**ADDENDUM NO. 2**

Re: **GS# 101-328**  
Dormitory Renovations  
Alcorn State University  
Lorman, Mississippi

**ADDENDUM NO. TWO (2)**

GS# 101-328  
Dormitory Renovations Alcorn State University  
Lorman, Mississippi  
ERG P.N. 23.123

ADDENDUM #2 (12/05/23)

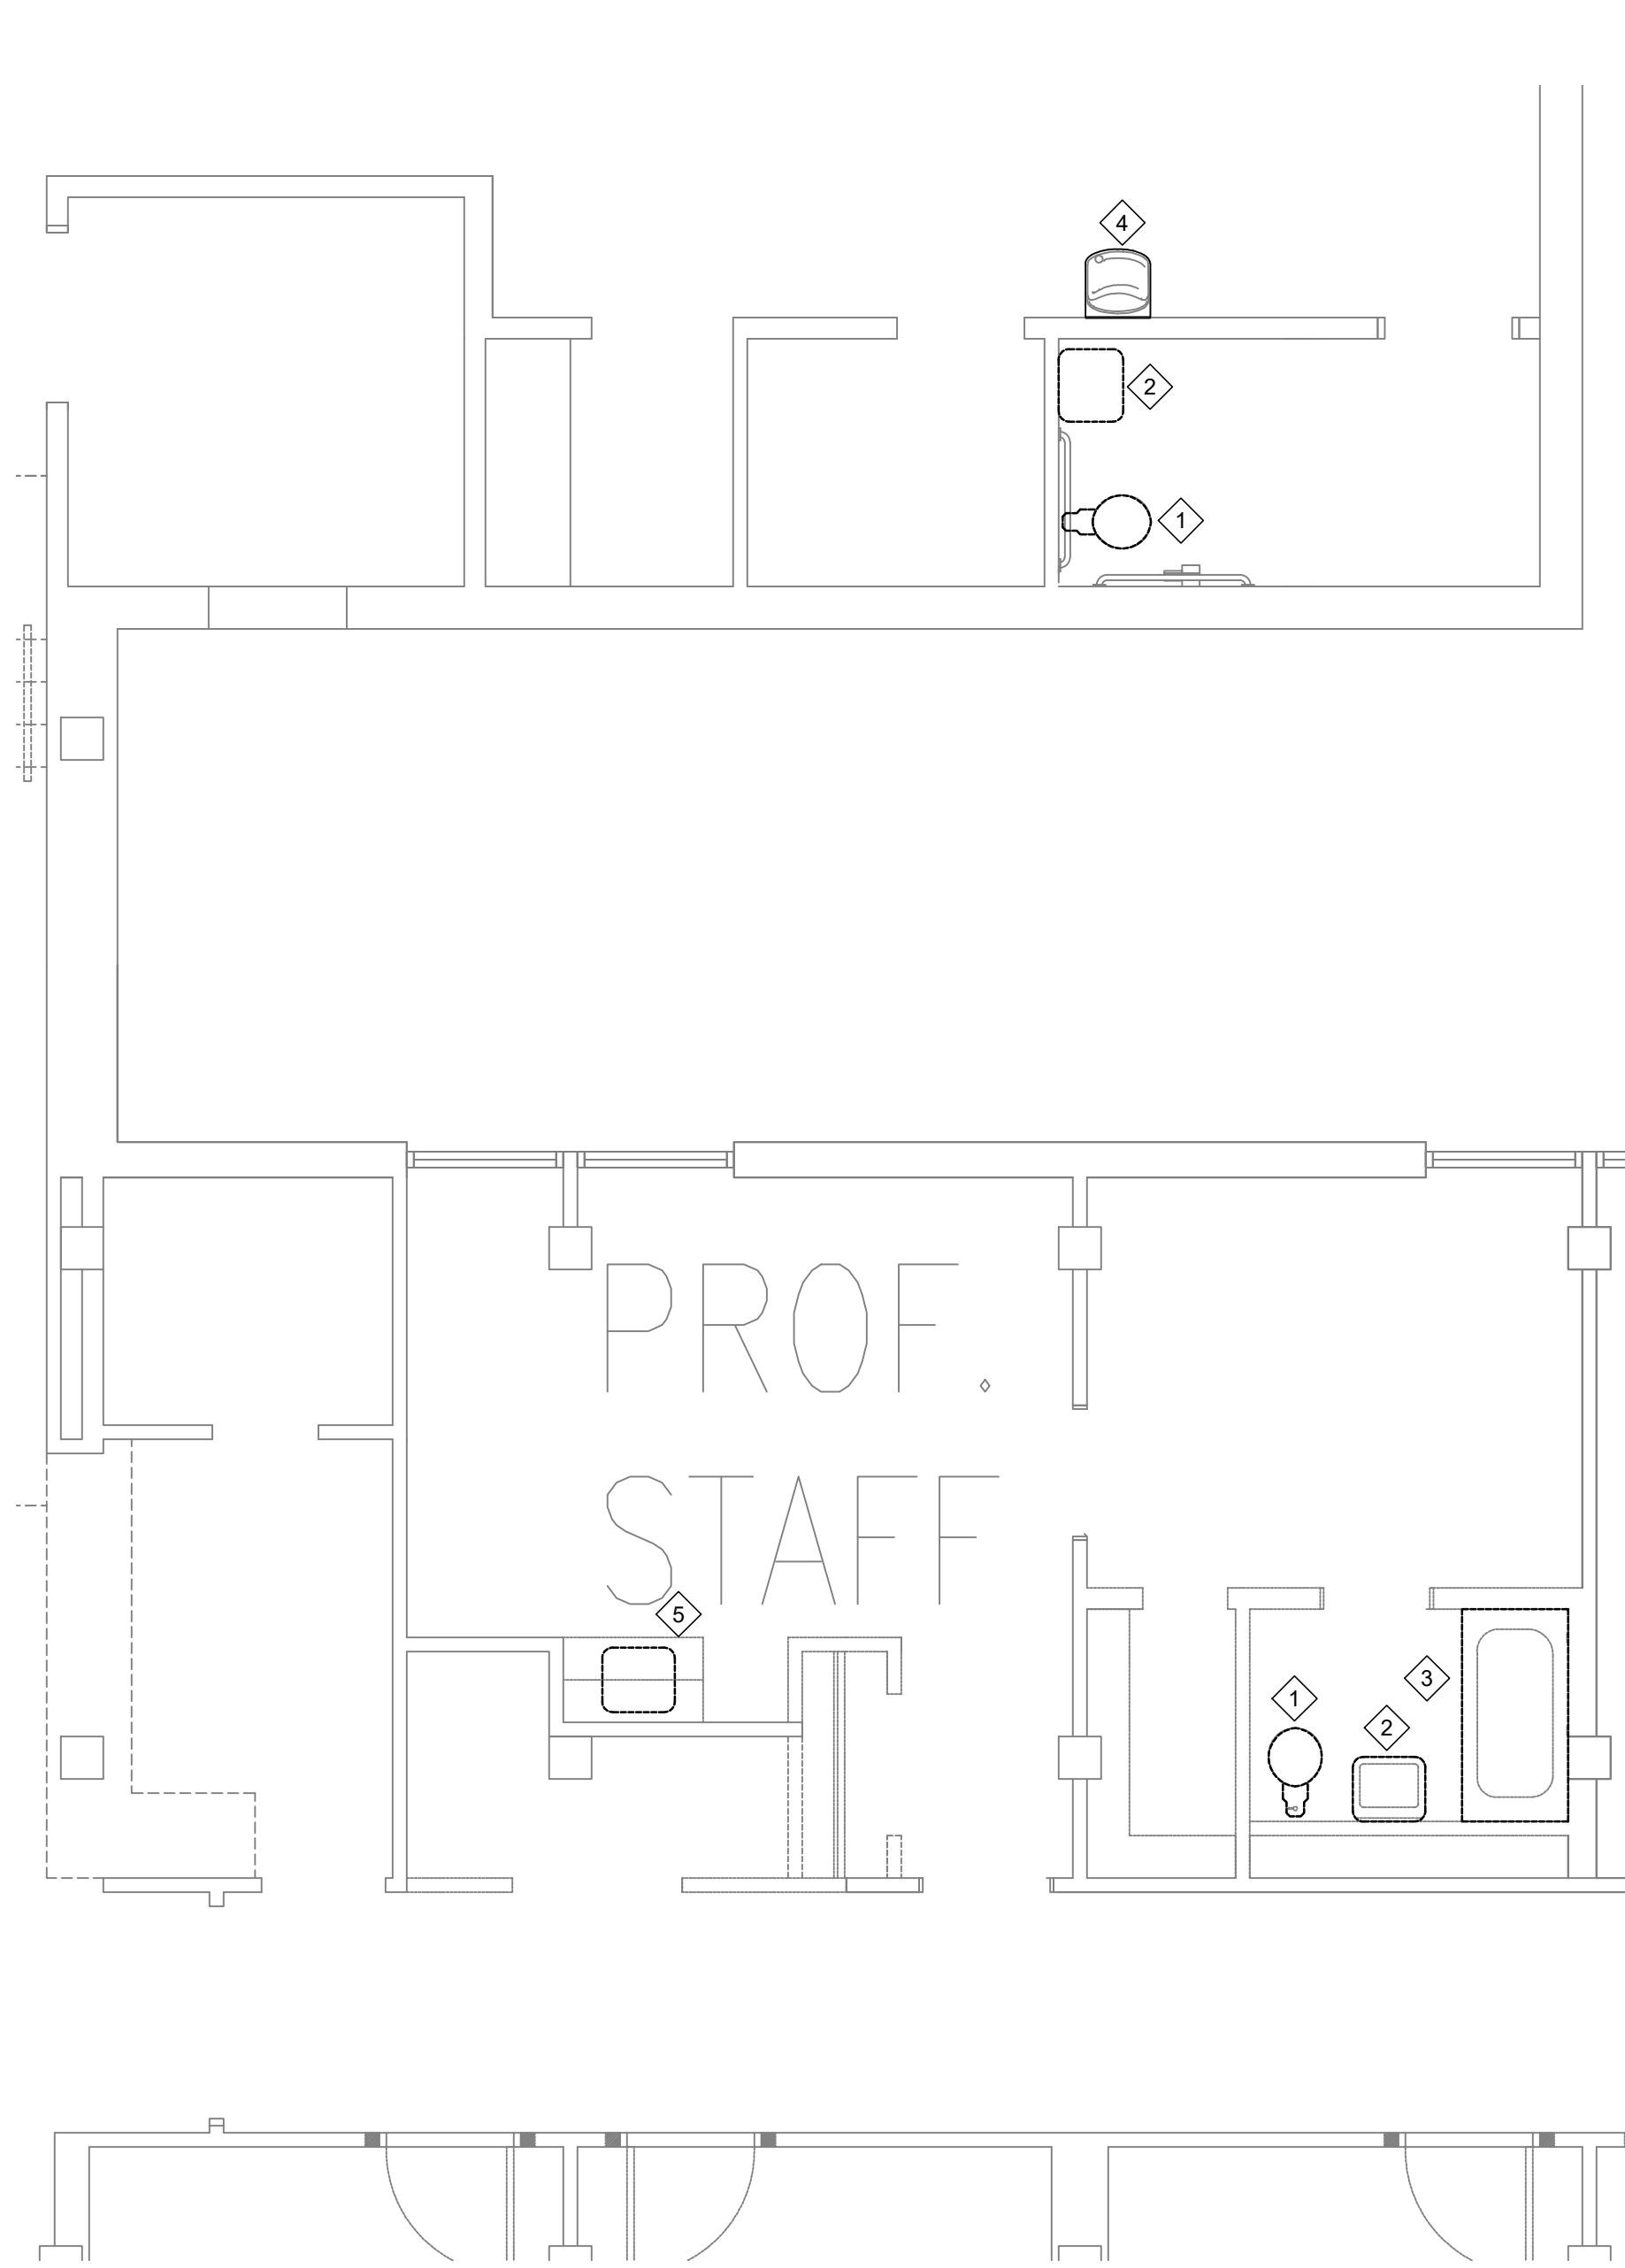
- A. Sheet P0.1: Revised Plumbing General Notes.
- B. Sheet P2.2: Relocated cold, hot, and hot water recirc mains from Dorm R24 to R30.
- C. Sheet P3.0: Revised piping at L-2 located in Prof. Staff Bed.
- D. Sheet P3.1: Revised filtration system and added Make/Model.
- E. Sheet P3.7: Revised piping at L-2 located in Professional Staff.
- F. Sheet P3.8: Revised filtration system and added Make/Model. Revised routing of cold, hot, and hot water recirc piping up to first floor.

- GENERAL NOTES:**
- A. REMOVE ALL EXISTING DOMESTIC WATER, WASTE/VENT PIPING, HANGERS, SUPPORTS, ETC.
  - B. CAP-OFF AND ABANDON ALL WASTE PIPING THAT IS RUNNING BELOW BASEMENT AND FIRST FLOOR SLAB UNLESS NOTED OTHERWISE.
  - C. SEE ARCHITECTURAL FOR SLAB REPAIR DETAIL AT SLAB-ON-GRADE CONDITIONS.
- PLAN NOTES:**
- 1. EXISTING WATER CLOSET AND ASSOCIATED PIPING IS TO BE REMOVED AND REPLACED.
  - 2. EXISTING LAVATORY AND ASSOCIATED PIPING IS TO BE REMOVED AND REPLACED.
  - 3. EXISTING BATHTUB AND ASSOCIATED PIPING IS TO BE REMOVED AND REPLACED.
  - 4. EXISTING ELECTRIC DRINKING FOUNTAIN TO BE ADJUSTED TO A.D.A. HEIGHT. REMOVE AND REPLACE ALL PIPING.
  - 5. EXISTING SINK AND ASSOCIATED PIPING IS TO BE REMOVED.

**ADE106**

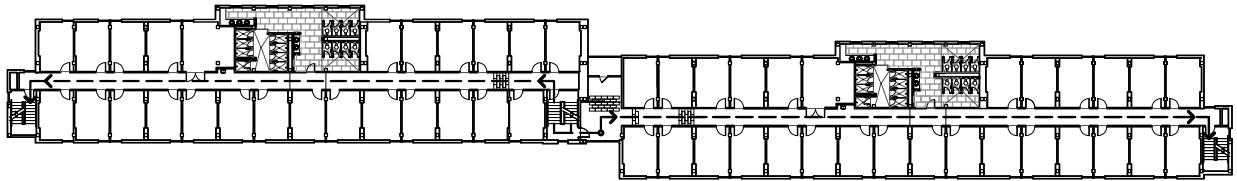
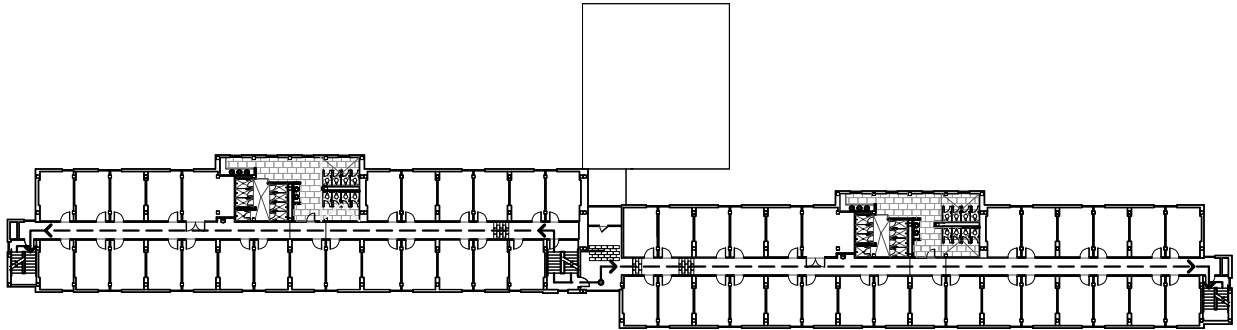
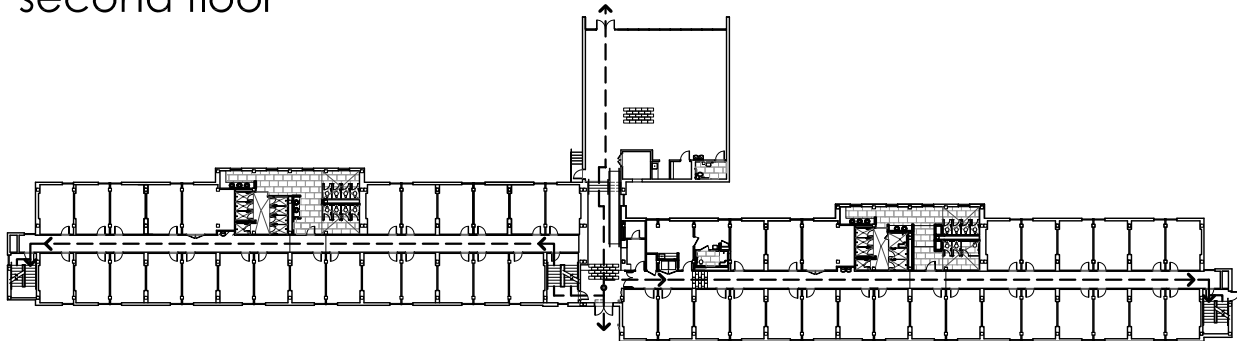
- C) Sheet E106, Circuit Schedules:

1) See attached sheet ADE106 for Panel “MSB” and Panel “MCC” schedules.

Egress Plan (Burrus Hall)

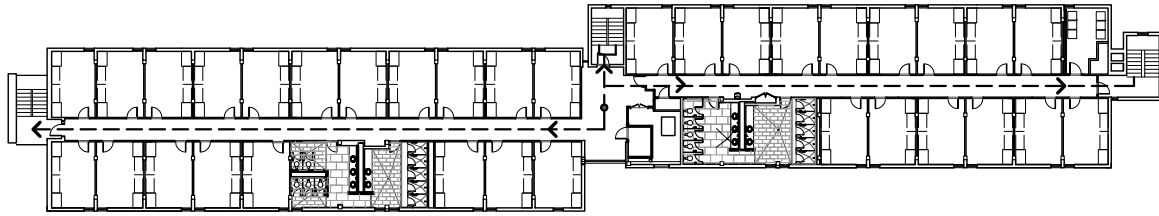
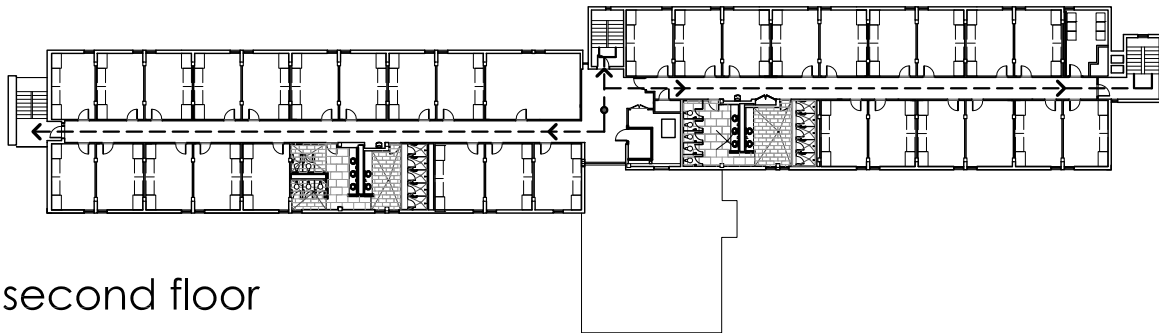
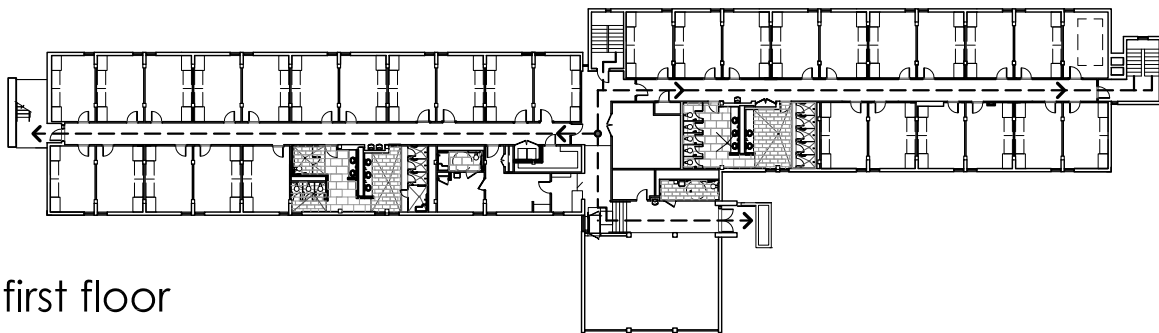
**Item No. 1:** Refer to Sheet TS and add egress plans per Exhibit “A”.

**EXHIBIT "B"**  
 SHEET 1 OF 2  
 (FROM DRAWINGS, SHT. 4.0)

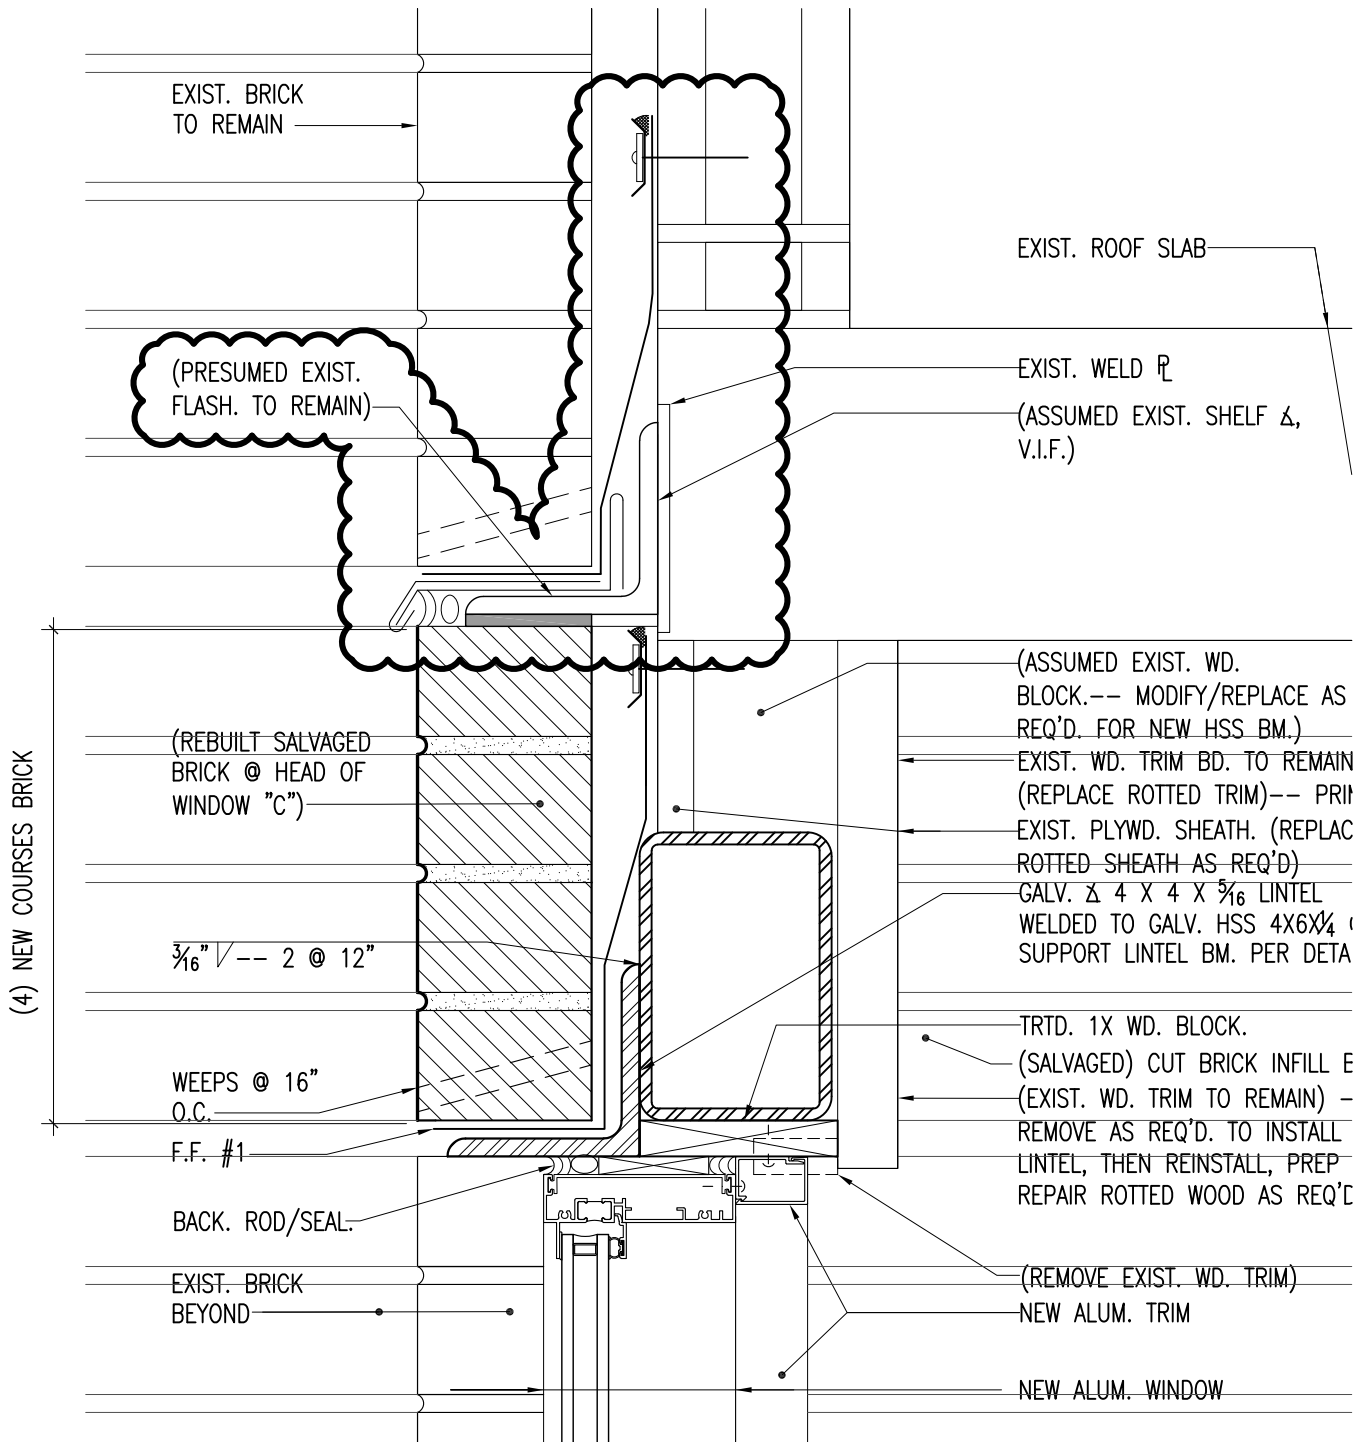
**Item No. 2:** Refer to drawings “1/4.0” and “1/6.1” and modify per Exhibit “B”.
